APPLICATION NO.	FILING DATE	FIRST NAMED INVENTOR	ATTORNEY DOCKET NO.	CONFIRMATION NO.
10/674,908	09/30/2003	Evon Llewellyn Crooks	030627/267420	9006

<b>Office Action Summary</b>	<b>Application No.</b> 10/674,908	<b>Applicant(s)</b> CROOKS ET AL.	
	<b>Examiner</b> JASON L. LAZORCIK	<b>Art Unit</b> 1791

12. Applicant was previously advised of the multicomponent filter structure disclosed by the noted prior art references. Such a cigarette structure was presented in the composite figure displayed on page 8 of the prior issued Official Action dated October 4, 2006 and said figure is reproduced below.

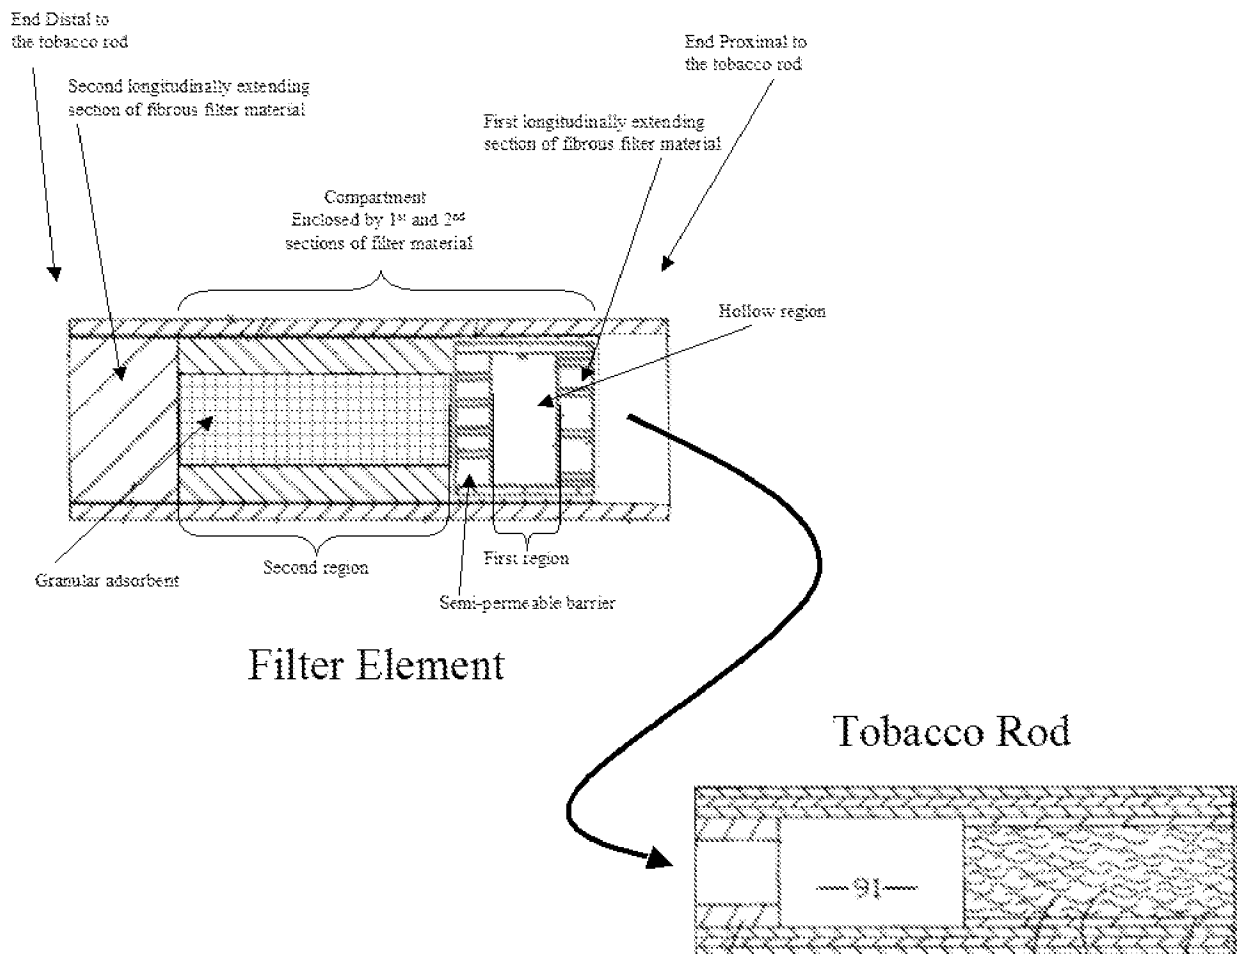
13. With reference to the composite figure, the prior art teaches a cigarette comprising a tobacco rod which the Examiner construes as that portion of the cigarette

circumscribed by overwrap (71). A first longitudinally extending section of fibrous tow is positioned proximal to and abutting the free flow filter element (71) of the tobacco rod. A second longitudinally extending section of fibrous tow is located at the end of the filter element distal from the tobacco rod. Both first and second sections of fibrous tow are circumscribed by tipping paper (64) or "a plug wrap". As noted in the figure, a compartment is defined by bounding the first and second sections of fibrous tow material with the tipping paper (64). A semi-permeable barrier partitions the compartment into a hollow first region and a second region comprising the Yang adsorbent material. Use of fibrous tow materials in the semi-permeable barrier and the first longitudinally extending section of material (e.g. sorbent segments (32) of the Zhuang filter (30) ) were rendered obvious in view of Keith and the ordinary level skill in the art at the time of the invention.

15. Regarding **limitation (a)** above, the filter element depicted in the composite figure clearly comprises a filter element proximal to the tobacco rod and abutting the tobacco rod" as recited in line 5 of claim 21 and in line 5 of claim 40.

16. Regarding **limitation (b)** above, the above filter element is by circumscribed by tipping paper (64) or "a plug wrap" thereby bounding the first and second sections of fibrous tow material and defining a compartment between said tow materials as recited in lines 8-10 of claim 21

Regarding **limitation (d)** and **Claim 24**, Yang teaches (Pg 6, ¶ [0058]) that the flavored carbon particles can be incorporated in various ways such as by being loaded onto paper or other substrate material which is *fitted into the passageway of the tubular free-flow filter element (102).* Where the prior art teaches an embodiment wherein the Yang adsorbent fitted into the passageway of the tubular free-flow filter (101), both sections of filter material and the semi-permeable barrier would reasonably viewed as being devoid of the Yang adsorbent material.
